Vermont Agency of Transportation

REQUEST FOR PROJECT REVIEW

Proj. Name and Number: Middlebury WCRS(23)

CONTRACT 1
FINAL PLANS
OCTOBER 2016

PROJECT NAME: MIDDLEBURY	
PROJECT NUMBER: WCRS(23)	
FILE NAME: z10g044bdr_nul_pl.dgn	PLOT DATE: 10/18/2016
PROJECT LEADER: A.P. GUYETTE	DRAWN BY: K.C. BARRY
DESIGNED BY: E.F. LAWES	CHECKED BY: S.E. BURBANK
OUTFALL MAINTENANCE ROAD LAYOUT	SHEET 27 OF 116

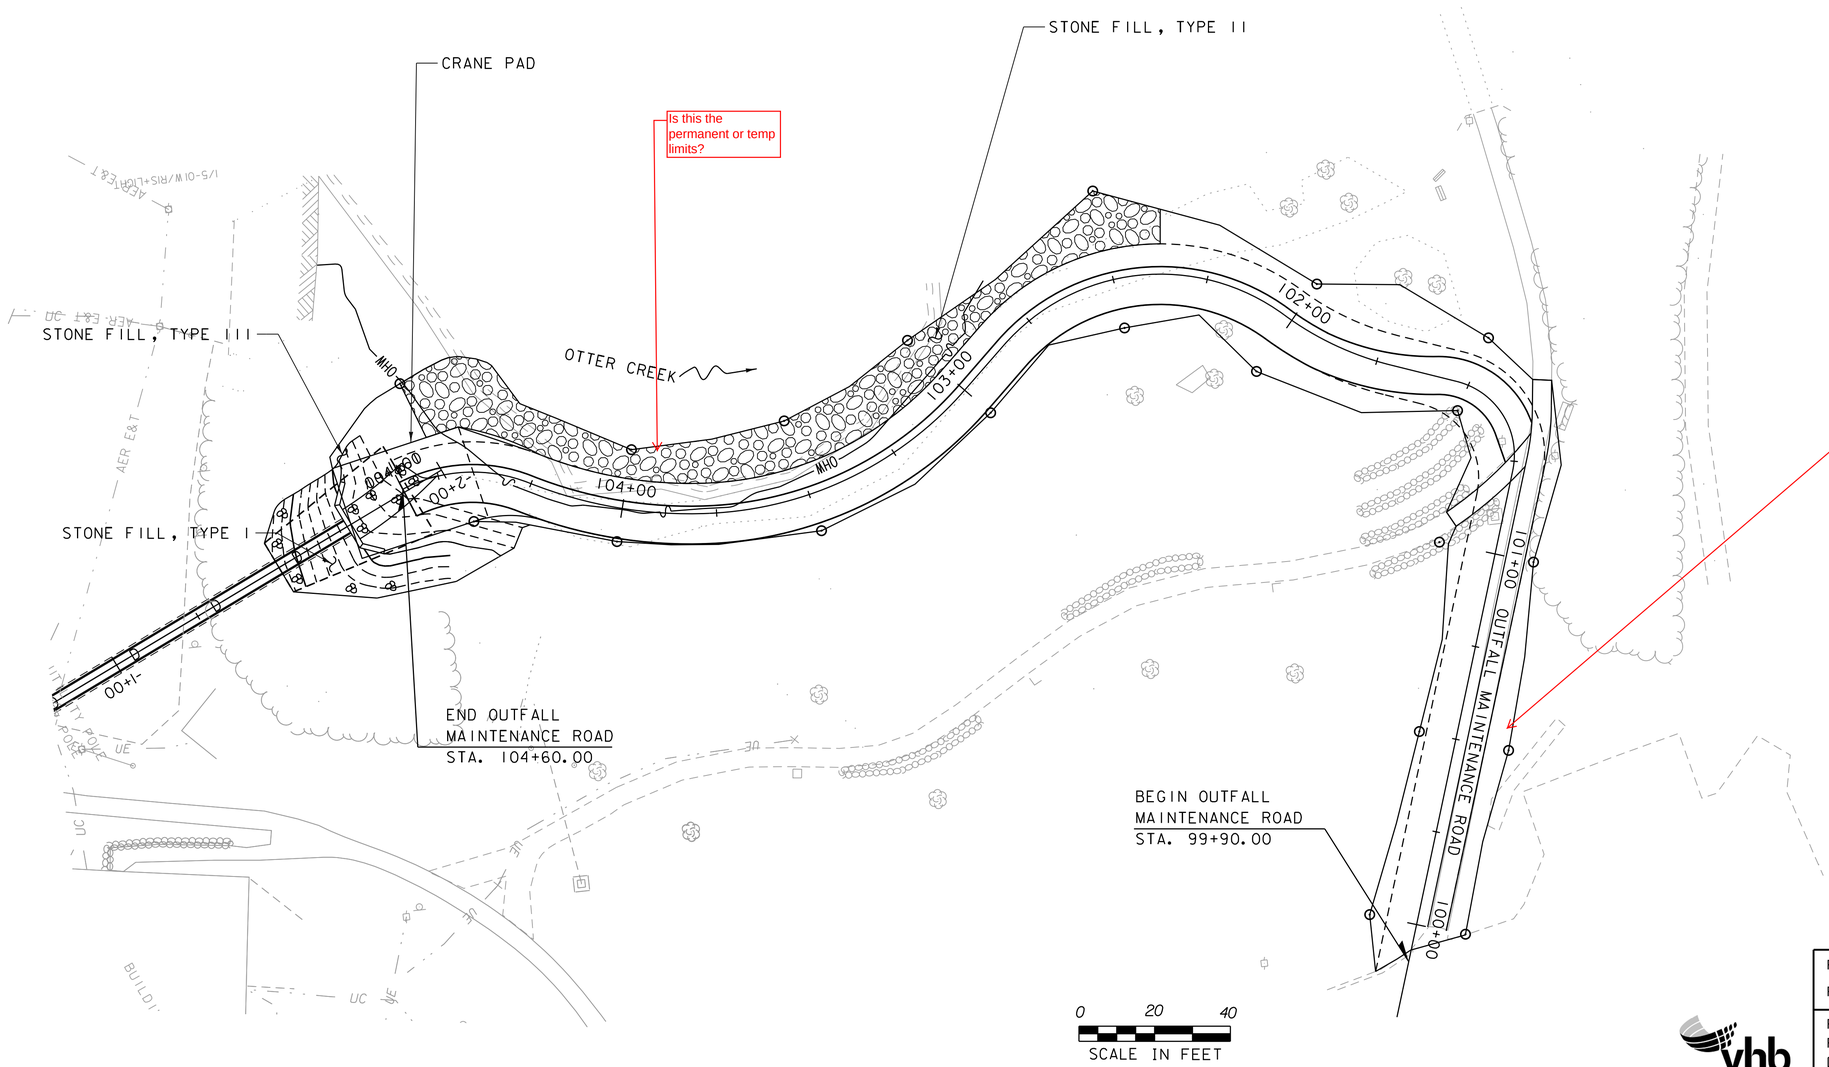
How will peds be directed during the few times that equipment will be using the road? If pavement becomes unstable than an alternative surface/route will need to be provided.

BLASTING ZONE

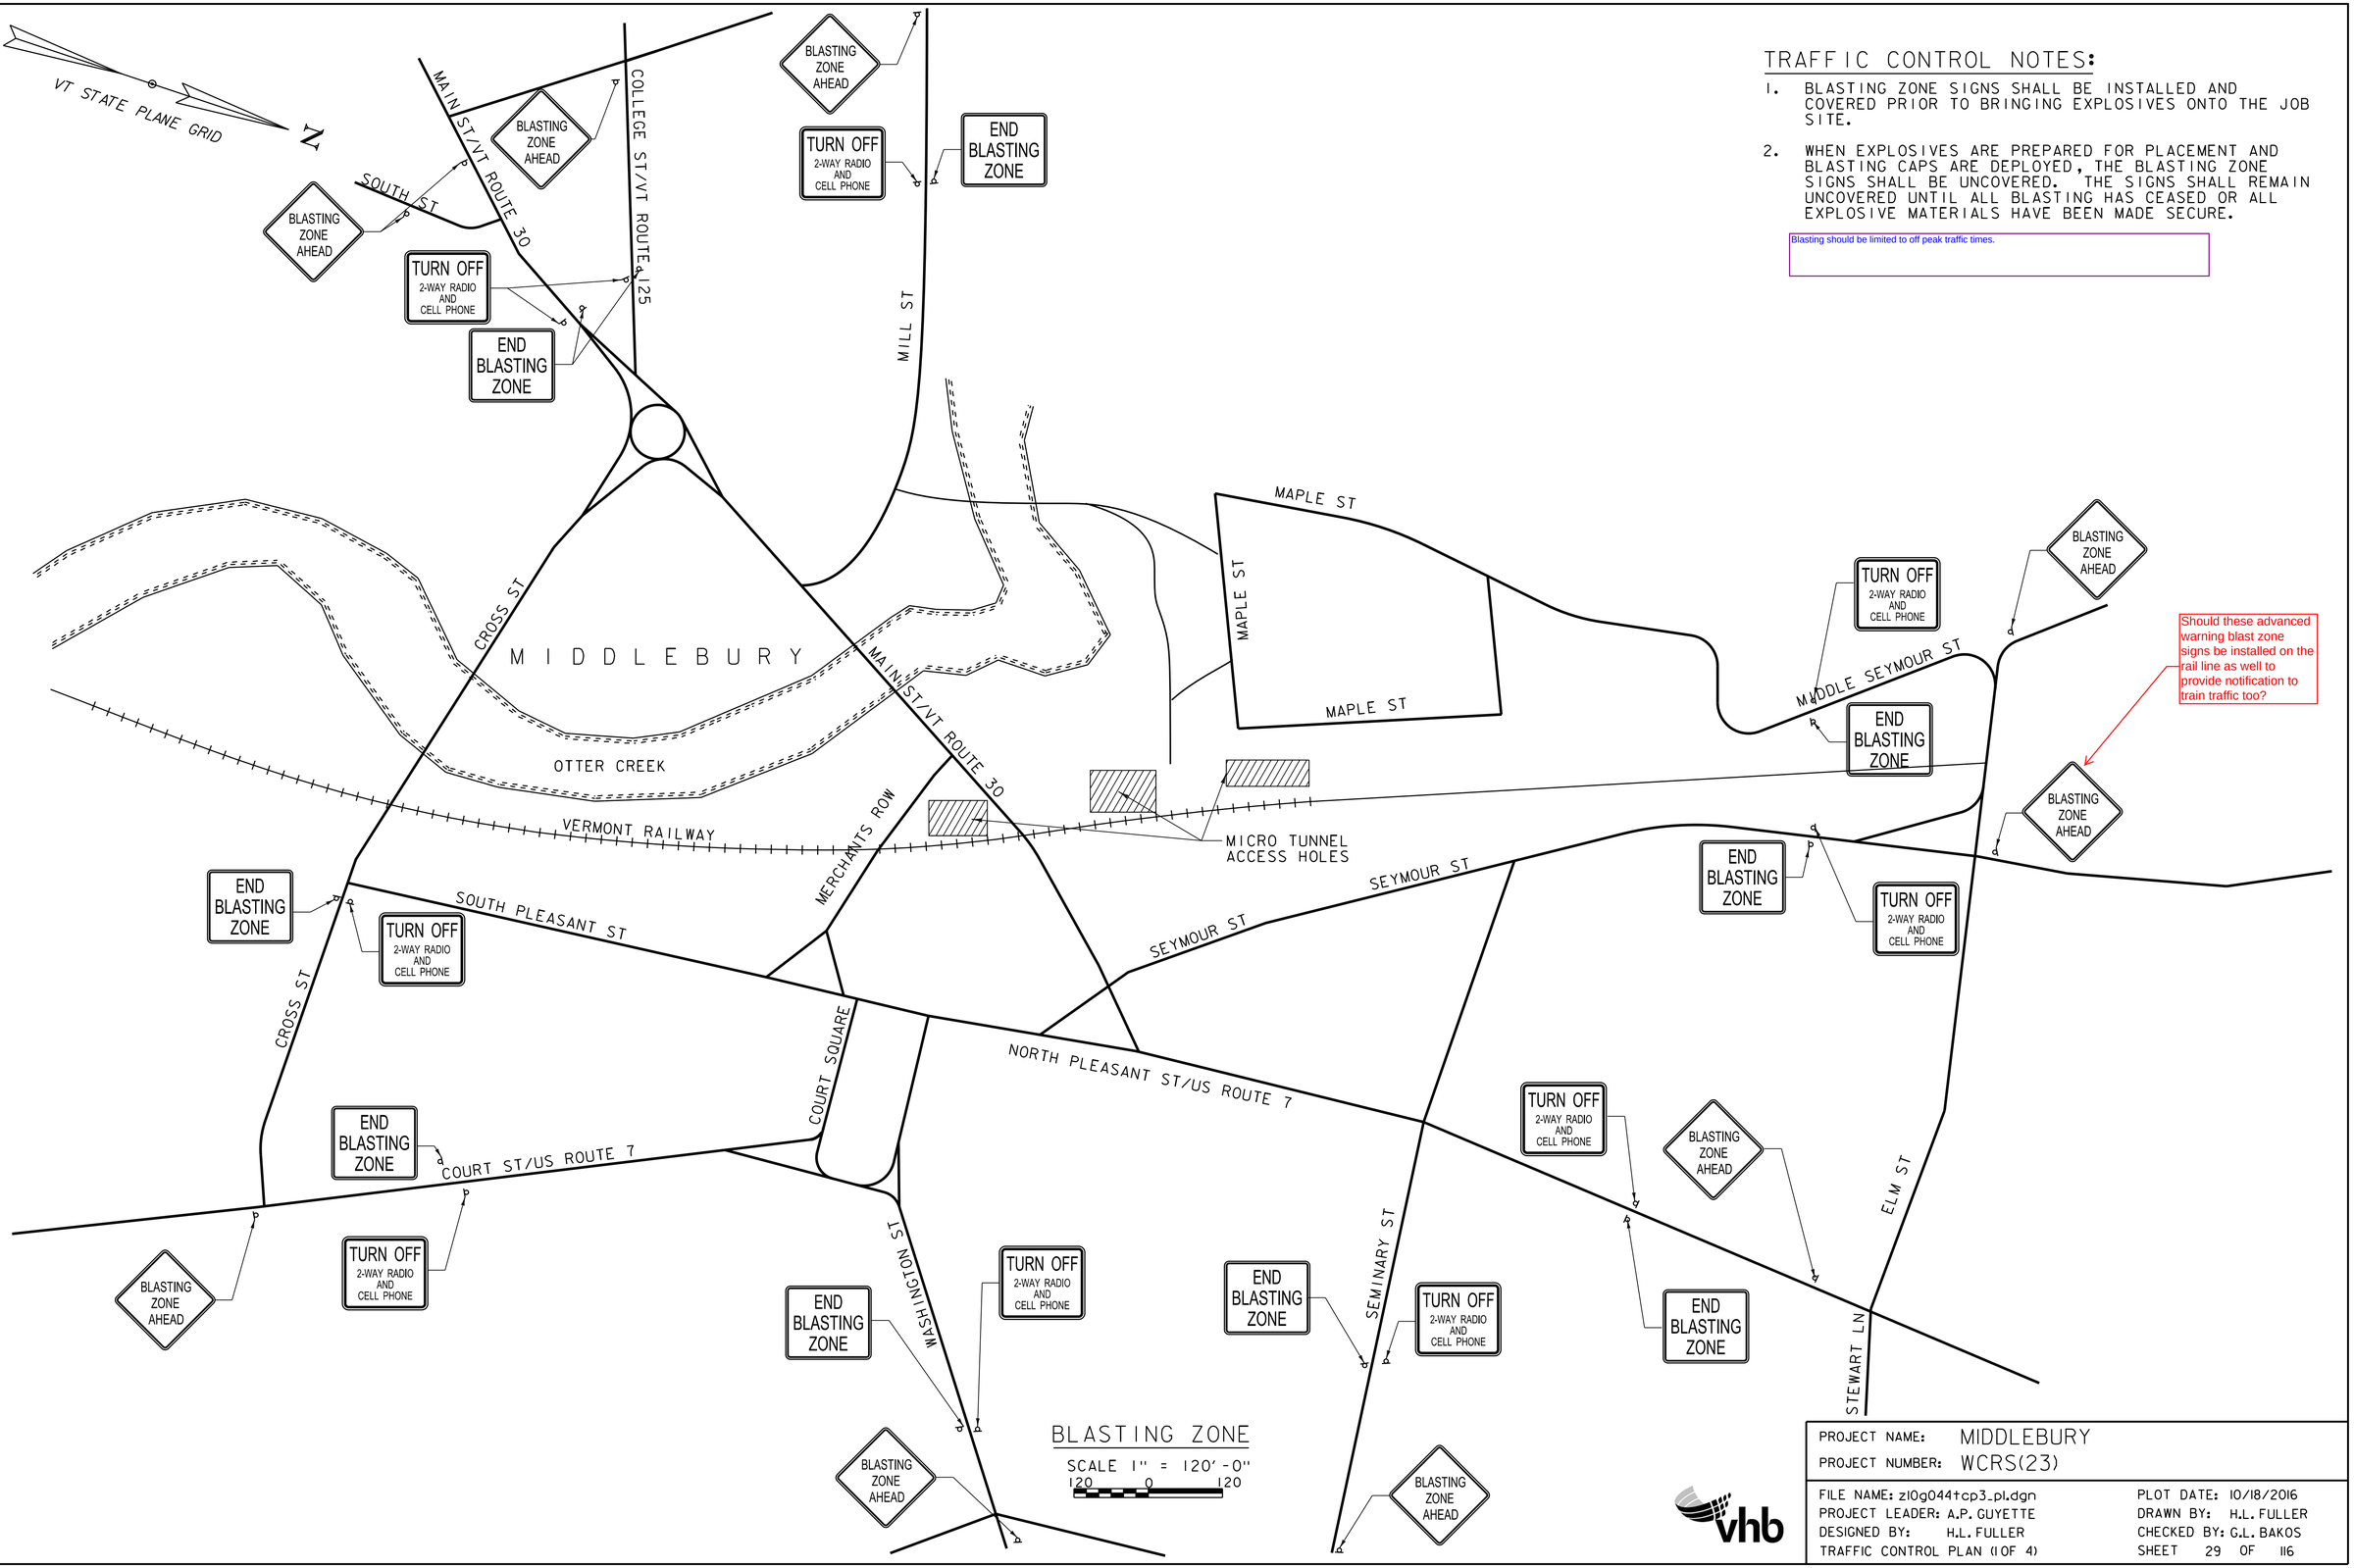
Blasting should be limited to off peak traffic times.

MICROTUNNEL PLAN

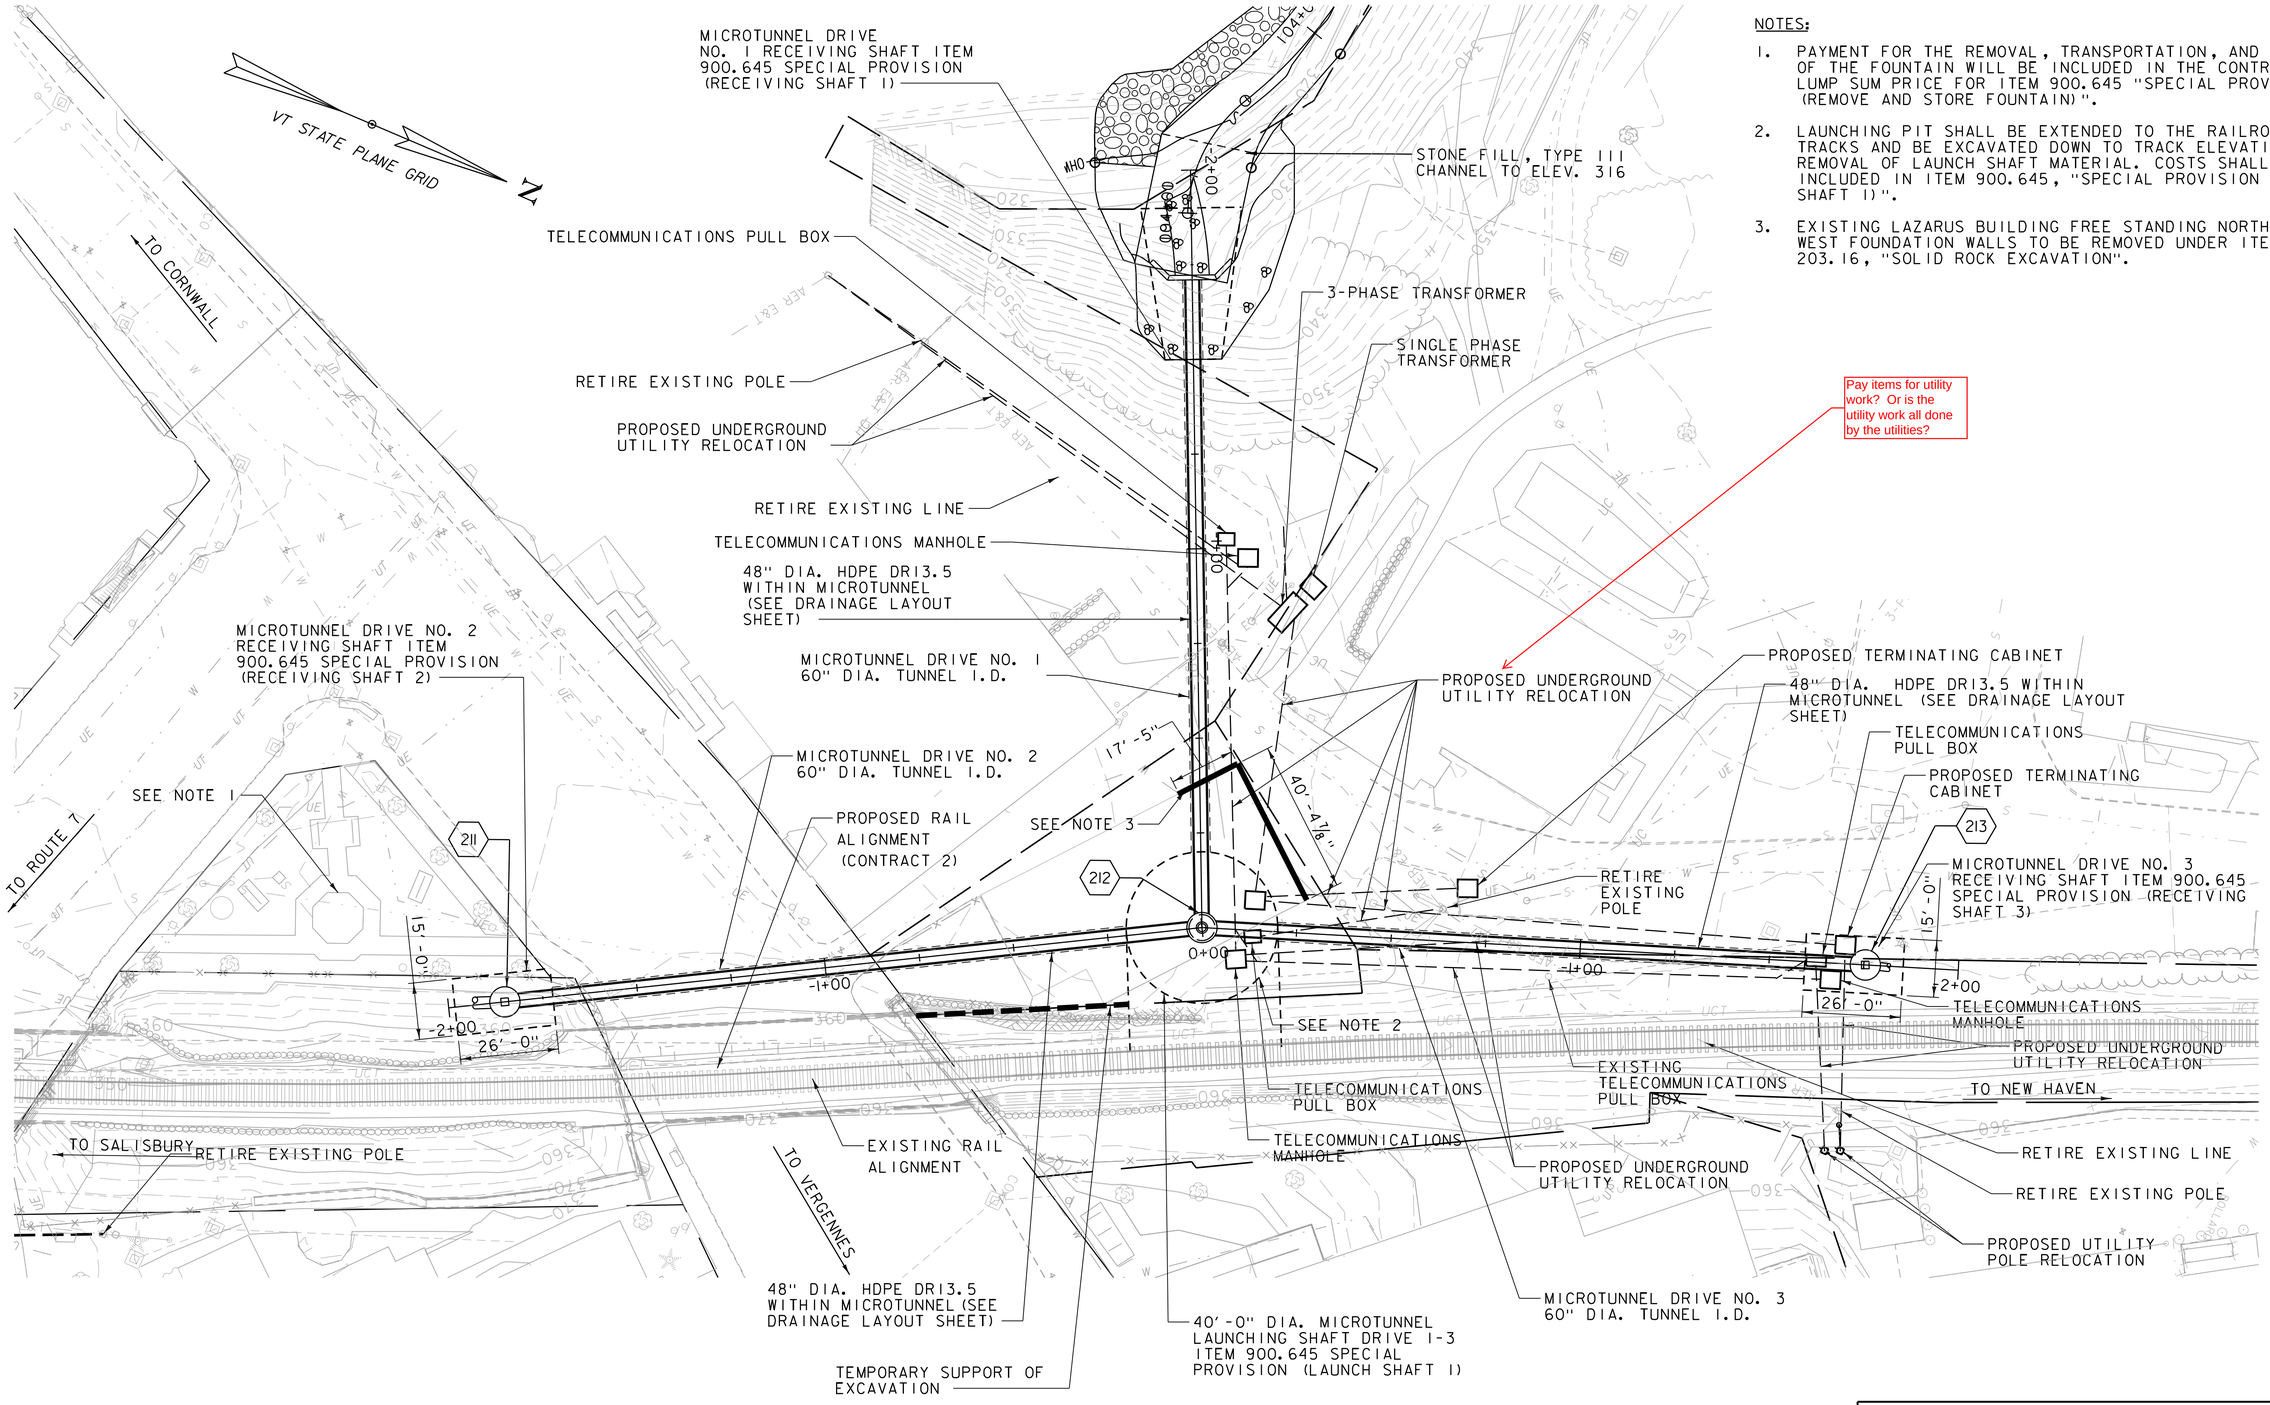
Pay items for utility work? Or is the utility work all done by the utilities?
